COSIMO'S BUILDING 87-47
Site Plan - real estate office
(Cuomo)

PROJECT NAME: COSIMO DiBRIZZI SITE PLAN
PROJECT LOCATION: ROUTE 207 AND MT. AIRY ROAD
PROJECT NUMBER: 87-47
DATE: 25 MAY 1988

PROJECT NAME: Cosimo-DiBrizzi Site Plan
PROJECT LOCATION: Route 207 and Mount Airy Road
PROJECT NUMBER: 87-47
DATED: 11 May 1988

PROJECT NAME: Cosimo DiBrizzi Site Plan
PROJECT LOCATION: Route 207 and Mt. Airy Road
NW#: 87-47
28 October 1987

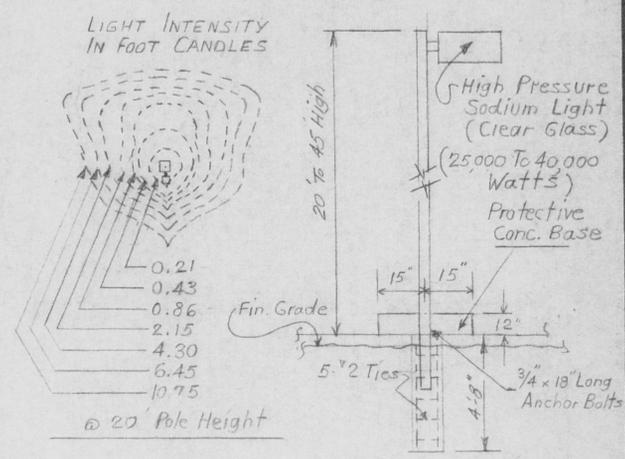
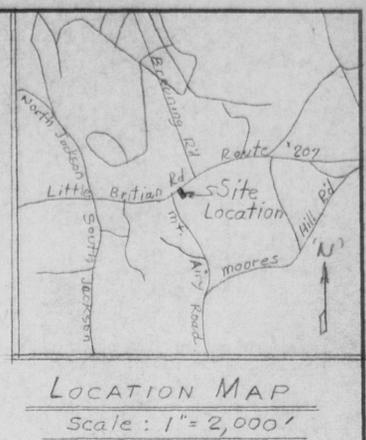
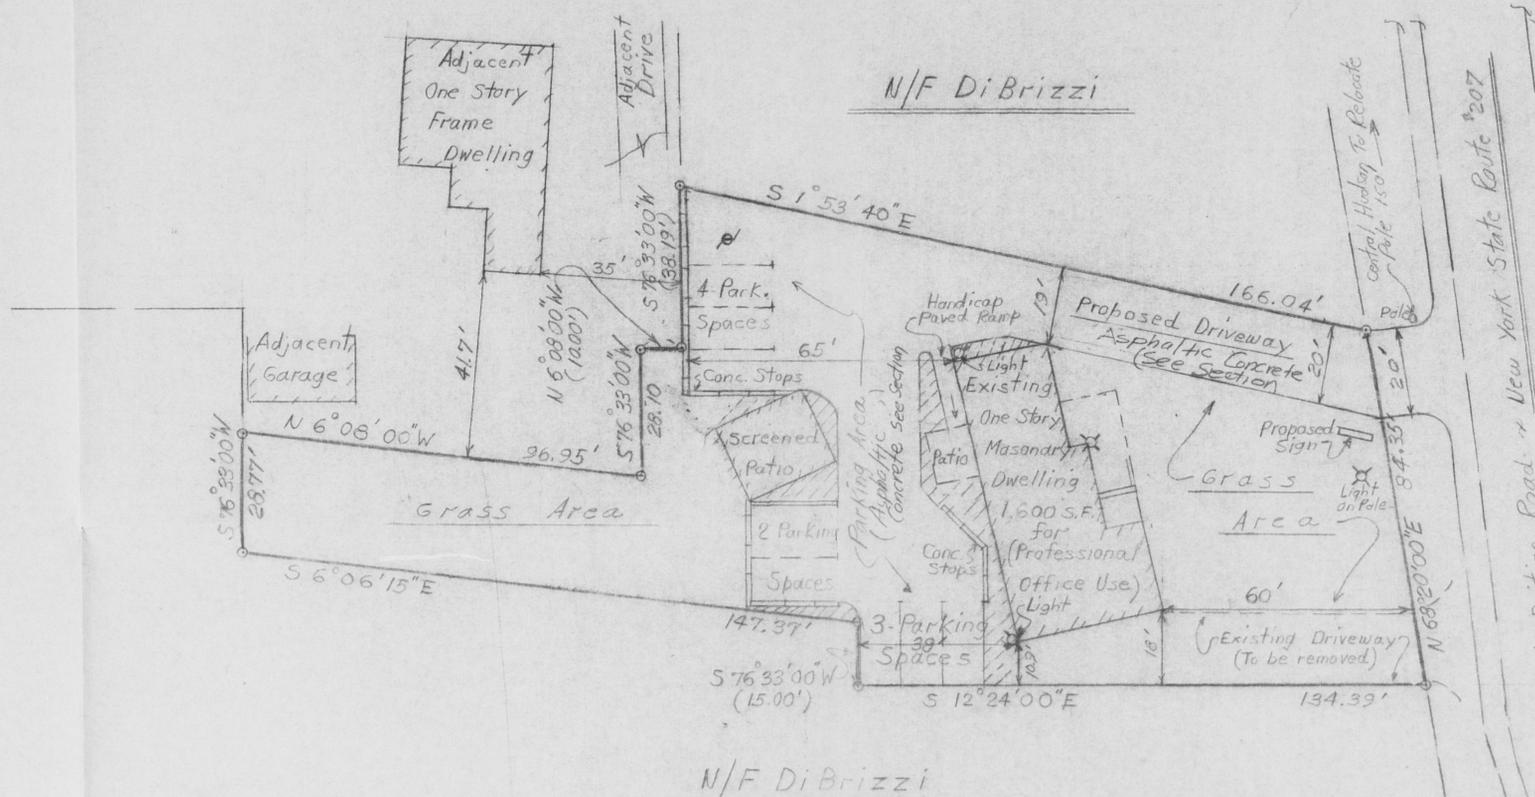
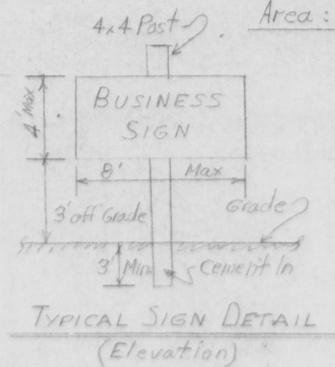
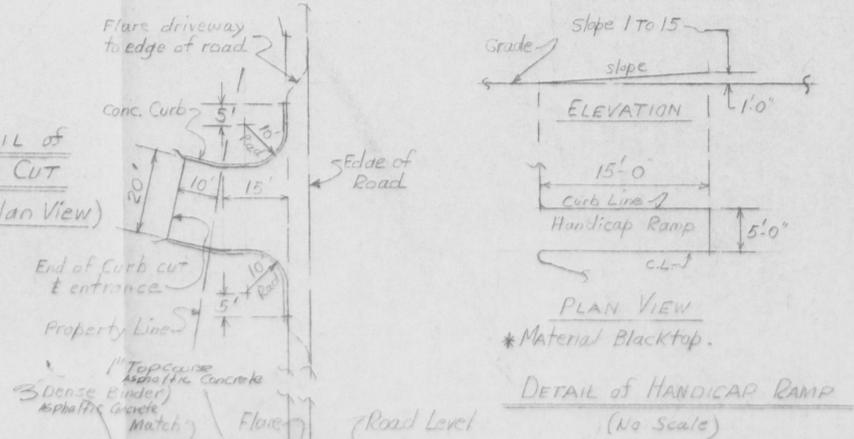
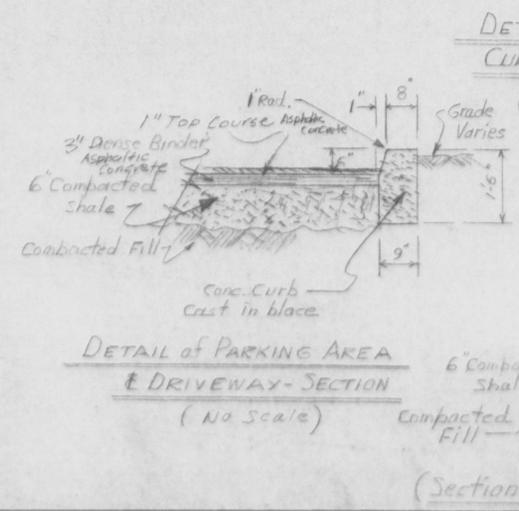
- a. The value indicated for lot width should be corrected (as previously noted).
 - b. The values indicated for "side yard" should be corrected (as previously noted).

- c. The table should be completed with regard to the values for frontage, building height, floor area ratio and development coverage.
 - d. The distance for the property boundary to the north of the property should be corrected; the length of 843.35' is incorrect.

3. The Board may wish to discuss with the Applicant the detail shown for the proposed business sign.
4. The detail for the parking area indicates a double surface treatment on a compacted shale. It should be verified with the Applicant's Engineer that the paving is satisfactory for access of emergency vehicles.

6. The Board may wish to verify that the "light on pole" shown near the front of the property is an existing light and is not the new light fixture indicated on the plan.

4. Prior to this plan being approved, I recommend that the following corrections/additions be made:
 - a. The Bulk Table should have the values for frontage, building height, floor area ratio and development coverage added to the table.

- b. The proposed lot width, side yard, both side yard should be corrected within the table.
 - c. Details of the site development (i.e. paving, sidewalks, landscaping, etc.) should be added to the plan.

5. The Board may wish to discuss the proposed use of the "screened patio".
6. Previous plans indicated that there was an "existing blacktop drive" on the east side of the existing dwelling; what is happening to this driveway as part of this site development?

7. The Board should note that the rear parking area is indicated as "gravel"; does this qualify as a dust-free surface under the Town Code?
8. It is recommended that the existing driveway to the west be upgraded to a 20' width, including the access to Route 207. This recommendation is pursuant to discussions with the Fire Inspector.

10. It should be noted that the Applicant is only required to have one (1) handicapped parking space. It may be advisable to change the handicapped space on the east of the screened patio to a standard space.

11. The handicapped access to the site should include paved surface from the provided handicapped space, as well as an acceptable handicapped ramp to the building entrance. Such improvements should be indicated on the Plan.

1. The Applicant was to change the pavement surface to delete the double surface treatment and provide for all areas to be blacktopped. The plan has been revised to indicate blacktopping for all areas as requested by the Planning Board.
2. It was requested that the Bulk Table be revised to indicate the correct lot width and not the 84.35' frontage value shown. This correction has not been made.
3. It was requested that the values for side yard be corrected. This correction has not been made.
4. It was requested that the Bulk Table be completed to indicate values for frontage, building height, floor area ratio and development coverage. These values have not been added to the plan.
5. The plan was to be revised to correct the distance for the property boundary to the north, rather than show the incorrect value of 843.35'. This correction has not been made to the plan.
